## Department of Planning and Zoning

**TO:** Development Review Board  
**FROM:** Scott Gustin *SG*  
**DATE:** September 17, 2013  
**RE:** 13-0707CA/MA; 3-11 & 13-15 George Street

**Request:** Demolish existing structures on George Street and construct new residential building above and behind existing historic structure on Pearl Street corner for total of 1 commercial unit and 23 residential units

George Street Apartments  
DRB Permit Application - Response  
August 21, 2013

sheet no.  
**A1.2**

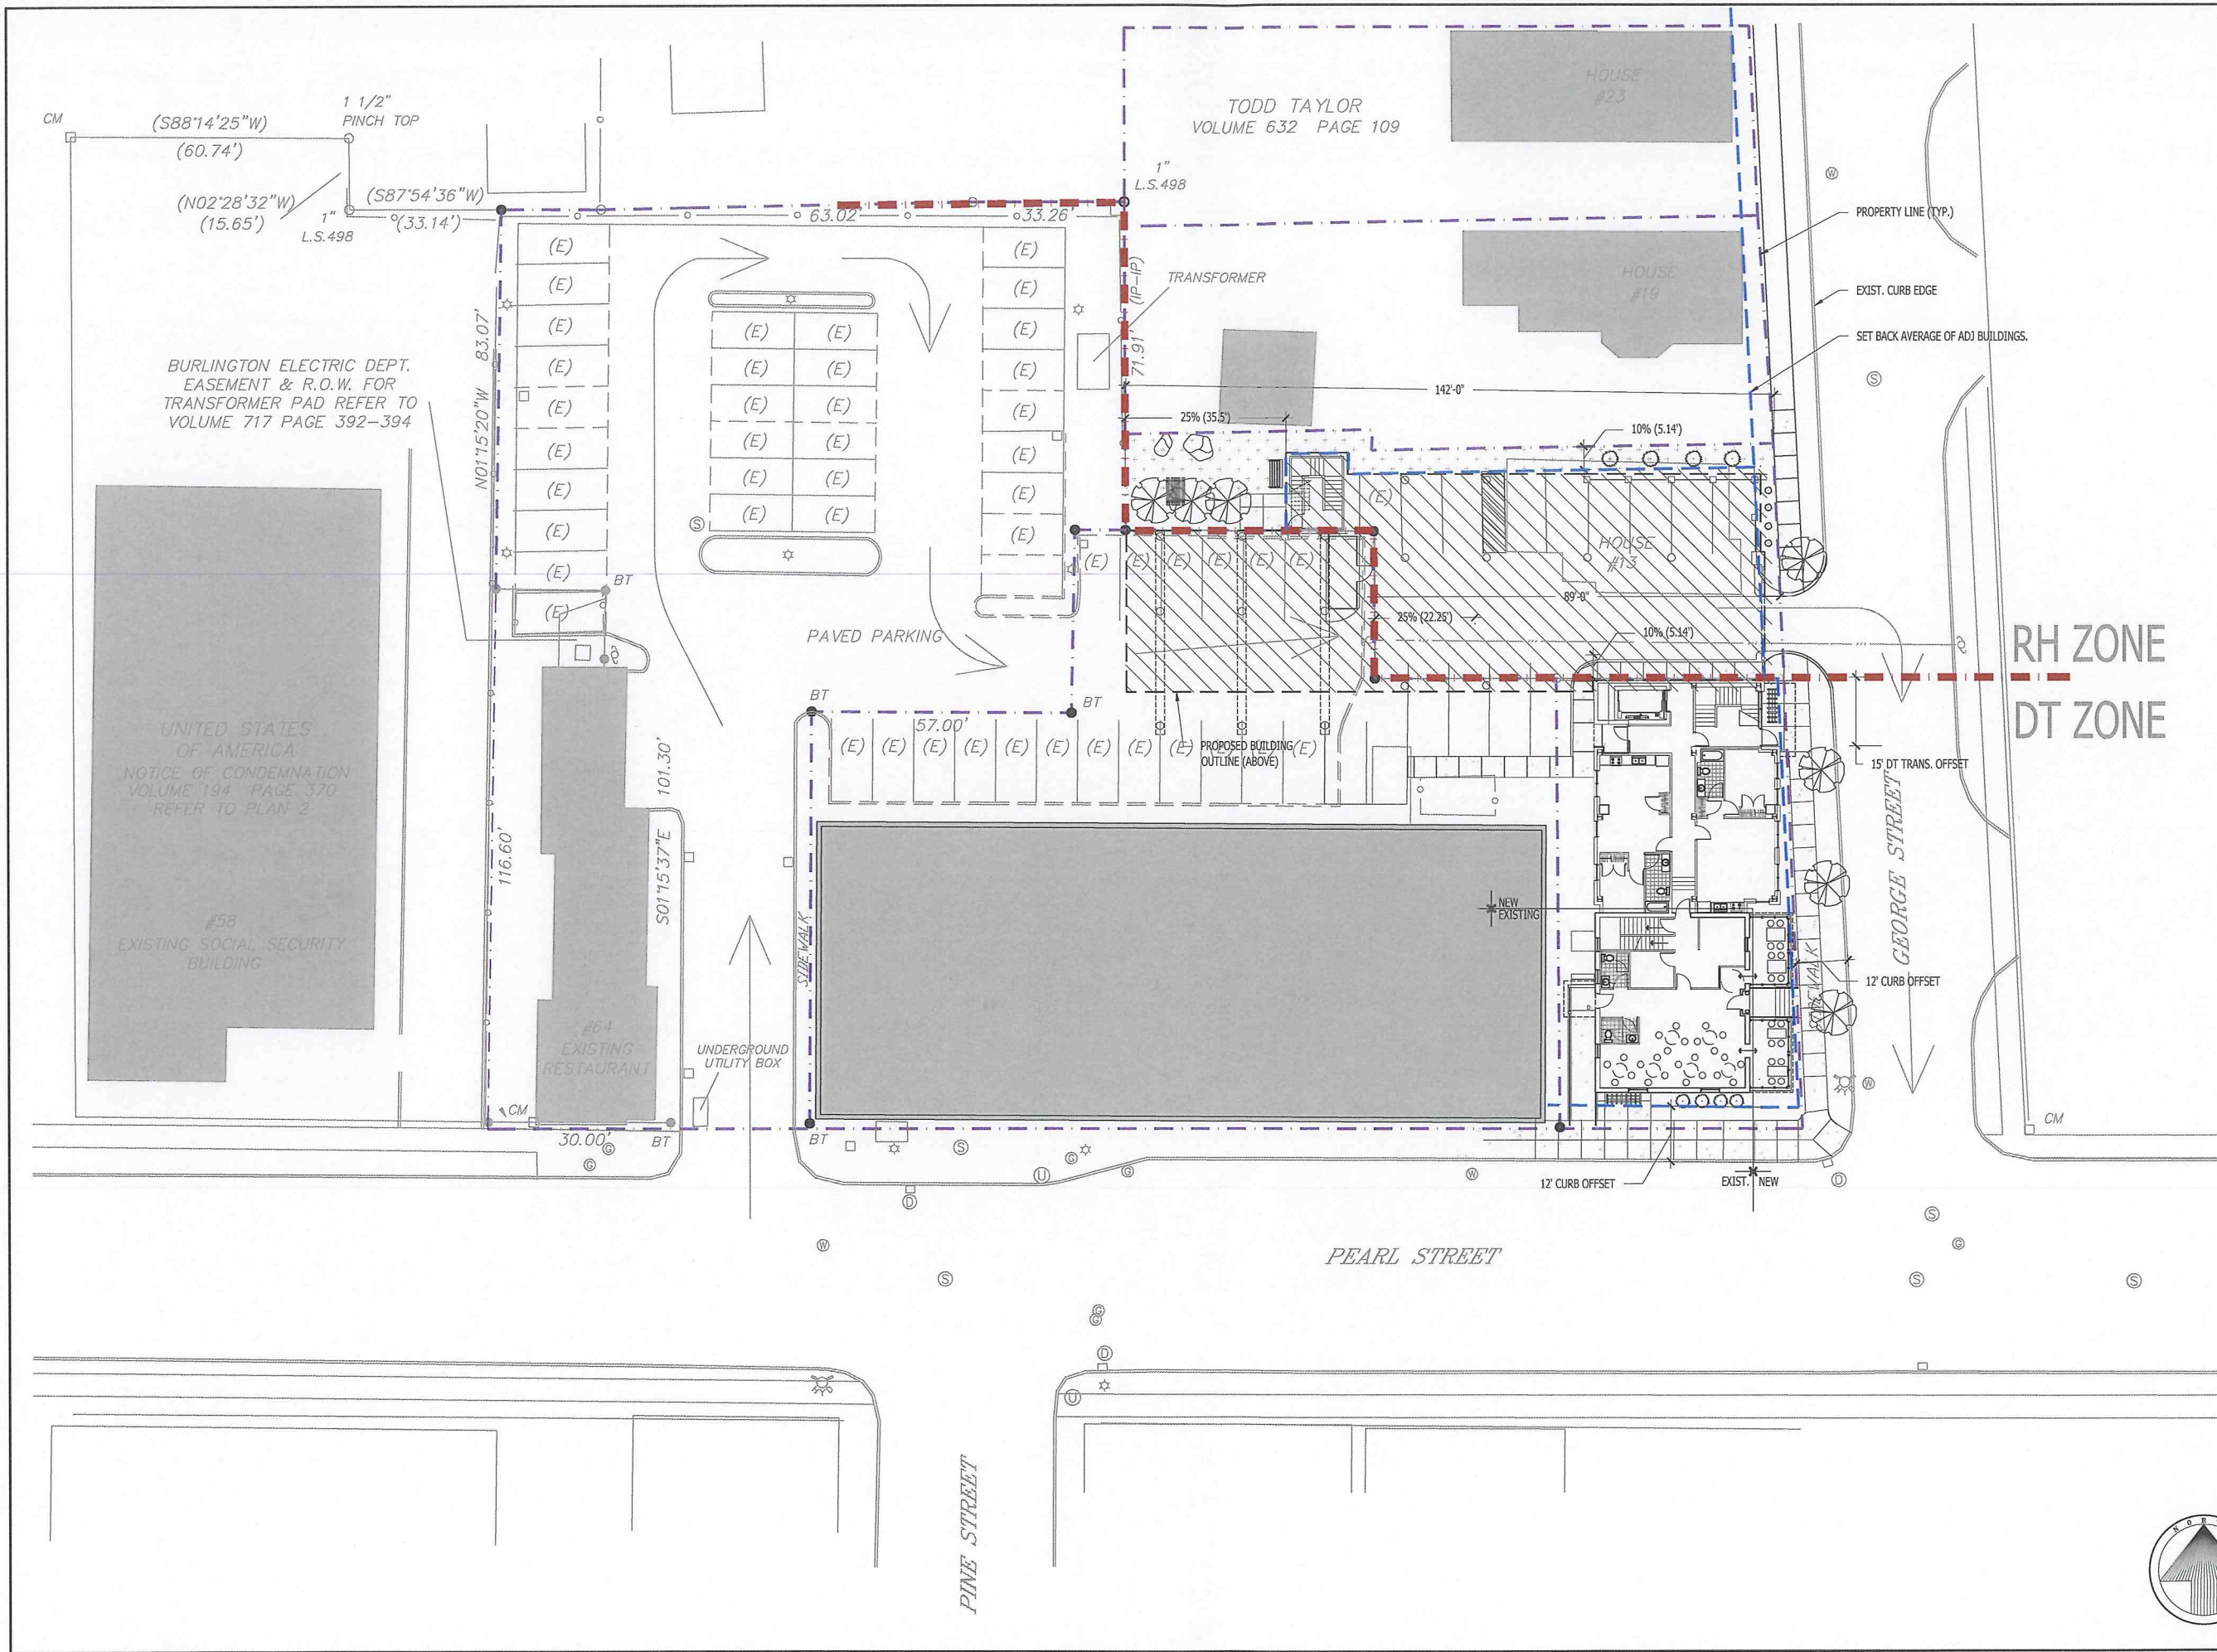
Only one setback applies to the DT portion of the proposed development – the 15' district boundary setback along the RH zone. The proposed construction does not comply with this setback requirement and, in fact, straddles the district boundary. The application asserts that by removing the property line (which is also generally the DT/RH district boundary) the setback requirement no longer applies. This reasoning misses the intent of the district boundary setback – to provide a break from intense downtown development for nearby residential neighborhoods – and quickly leads to absurd results. By this reasoning, this required setback could be avoided along the entire length of George Street (or any other street adjacent to the DT zone) by consolidating all of the properties. District boundaries generally, but not always, follow property lines in existence at the time the district boundaries are drawn. Removal or adjustment of the property lines does not eliminate the district boundary setback requirement.

The front yard setback is based on the average front yard setback of the neighboring properties – in this case the two neighboring properties to the north along George St. These two neighboring homes are set up to the front property line. Therefore, the proposed building may be up to the front property line or set back as far as 5'. The proposed building is set up to the front property line. The minimum required side yard setback is 10% of the lot width or at least 5' if the lot is narrower than 50'. The subject property is 45' wide and requires a 5' minimum side yard setback. As noted previously, the proposed development will straddle the property line (and zoning district boundary) and does not comply with this minimum setback requirement. Adjusting the southern side property line may affect the minimum 10% setback requirement; however, the application depicts no adjustment. Adjustment is simply contemplated in the application.

1. Existing site plan showing current lot lines and setbacks: Attached are C-1 by Ruggiano Engineering - originally filed with our first DRB Sketch Plan application in January of 2013. Since then, we have been showing a cleaned up version with existing and proposed setbacks- also attached.
2. Photographs of existing conditions: We have incorporated photos of existing project structures and surrounding buildings into our presentations. Attached are proofs of same for your reference.
3. Setbacks:

abuts another RH parcel. If the Board feels that the rules can be applied across the zone line, we would similarly like use the DT zone area to increase the allowed density on the RH parcel. Rather, we continue to support our original proposal which has tried to keep full integrity within each zone. Each portion complies with the criteria specific to the zone it is in. The property line setbacks/zone line setback along the merged line are the only criteria that are modified -and that appears to be legally allowed.
